LEGACY CHURCH - GREEN MOUNTAIN FALLS, CO DEVELOPMENT PLAN

COVER SHEET
SHEET 1 OF 13

Site Plan_v2_redlines.pdf Markup Summary

OVERALL SITE PLAN
 SHEET 2 OF 13

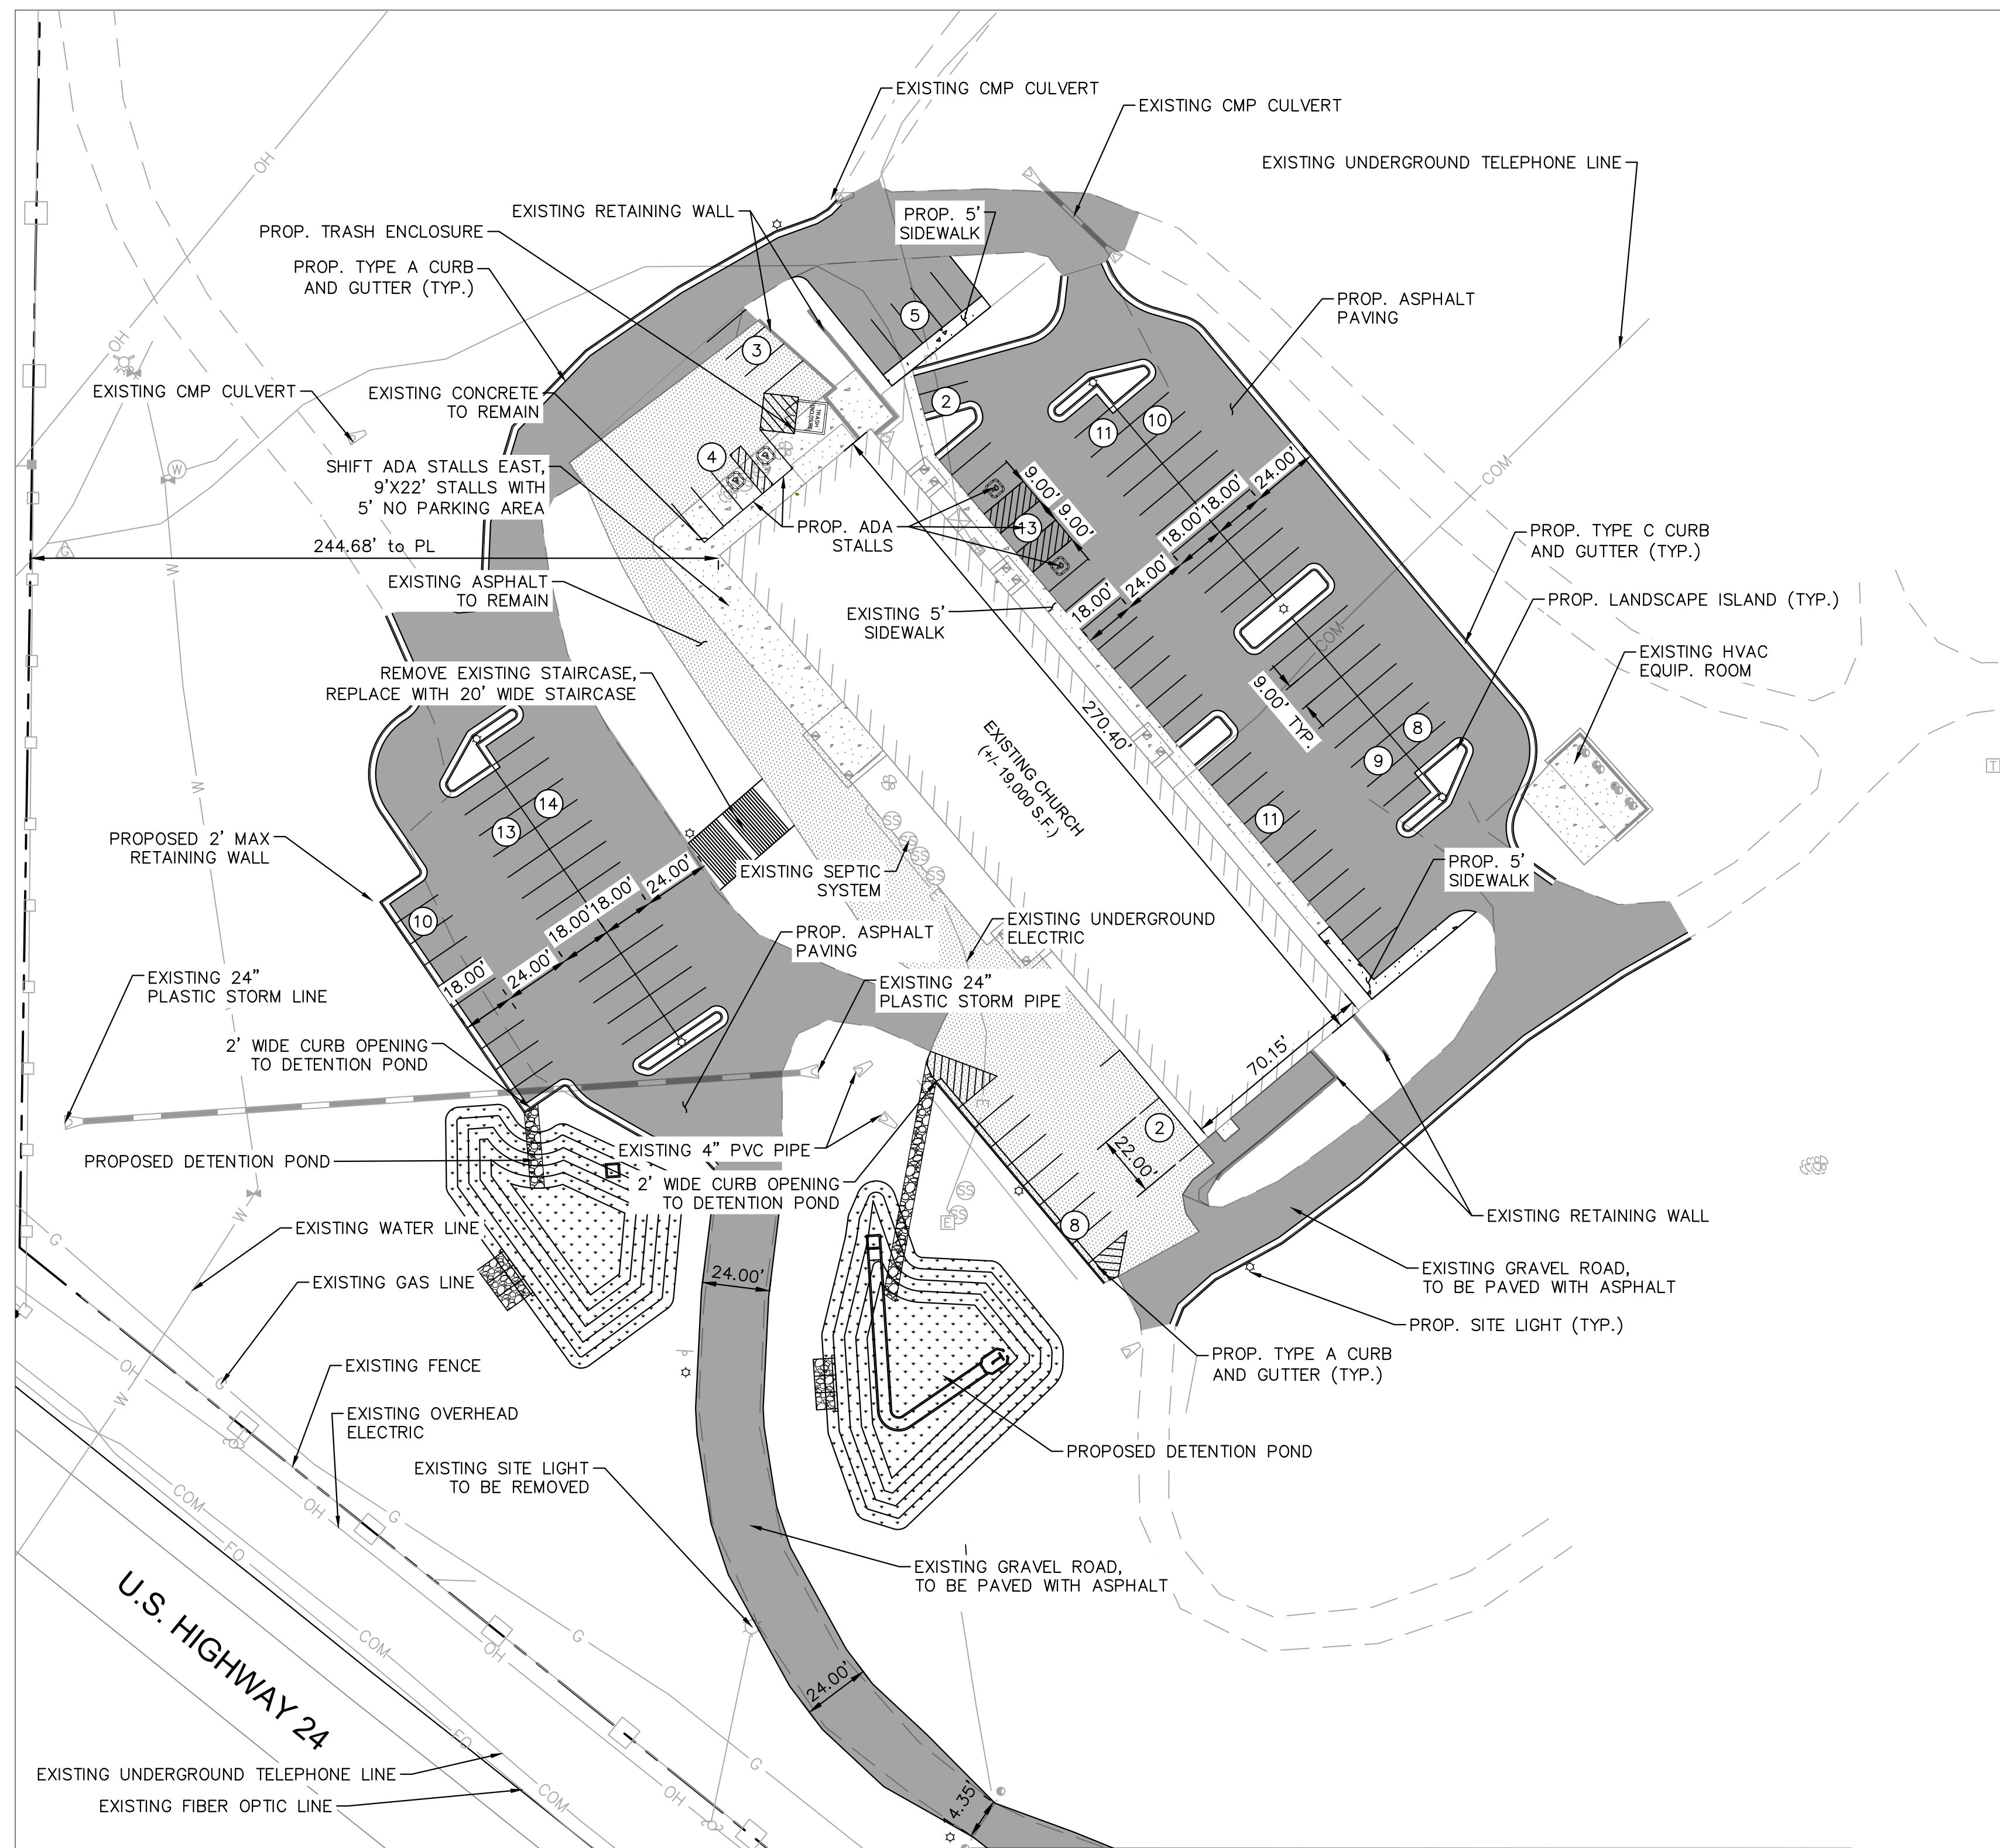
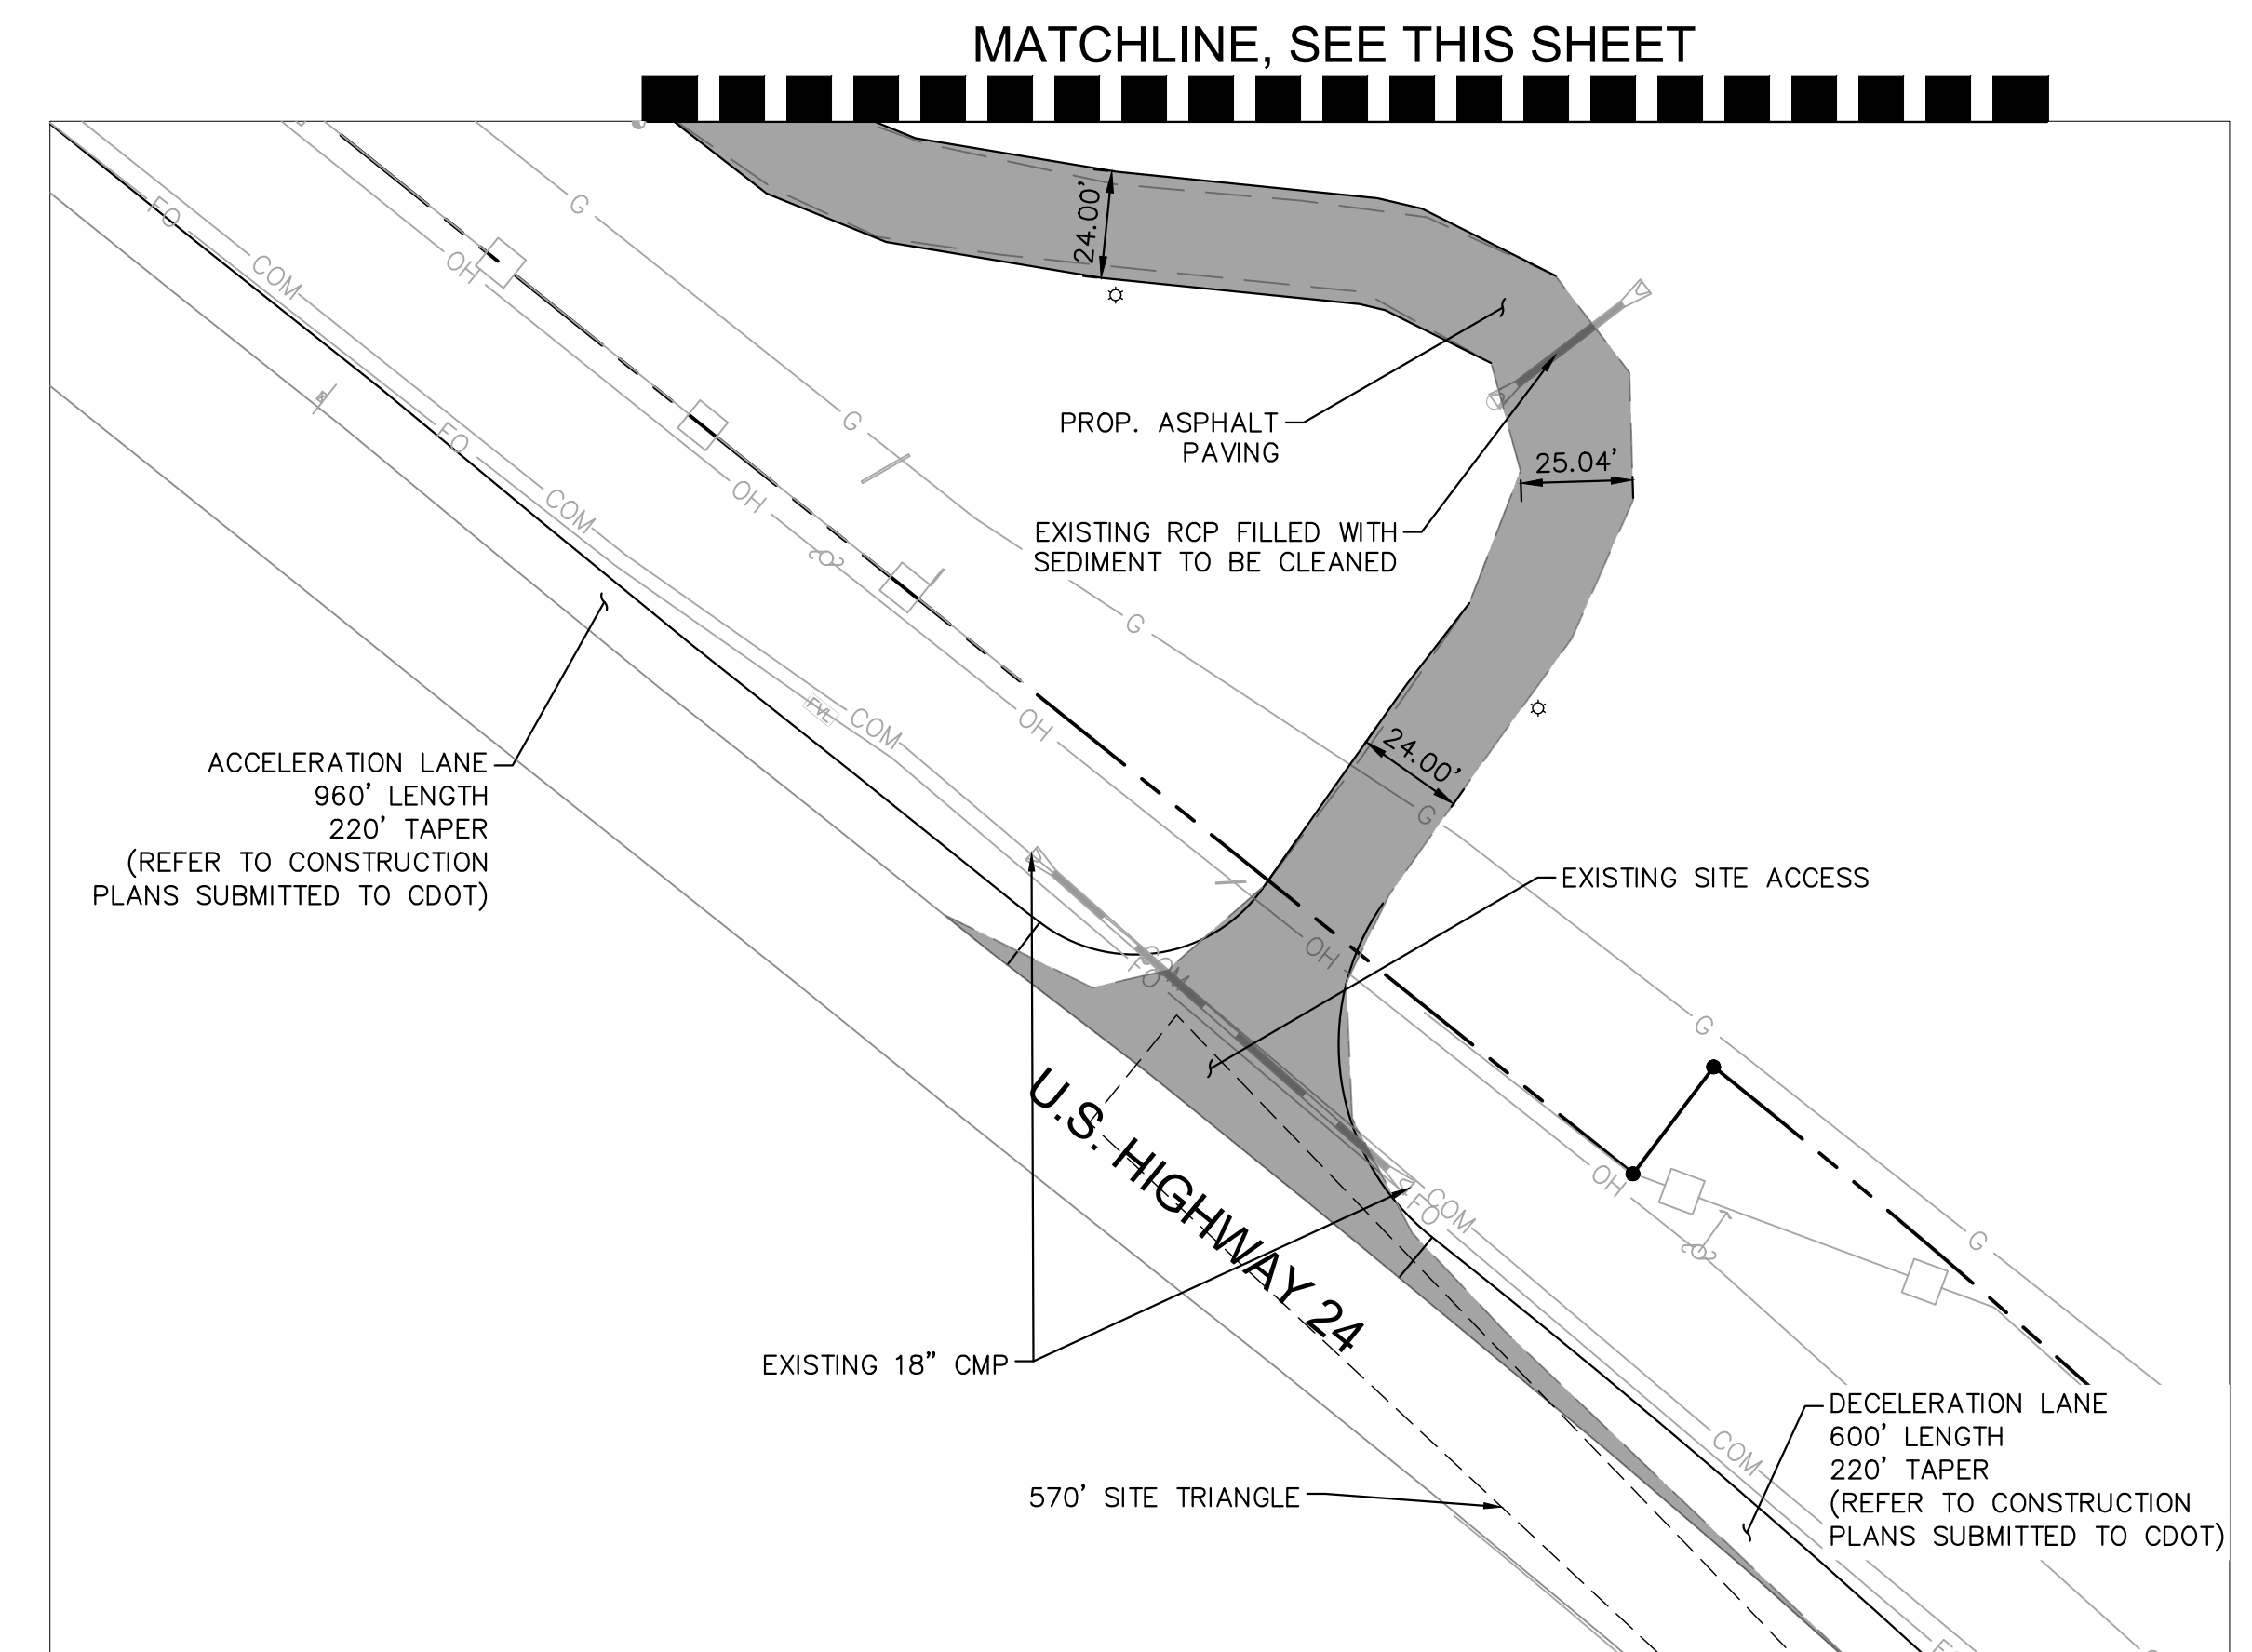
The letter of intent and the site plan on sheet 3 indicates 423 seats. Please revise accordingly.

The letter of intent and the site plan on sheet 3 indicates 423 seats. Please revise accordingly.
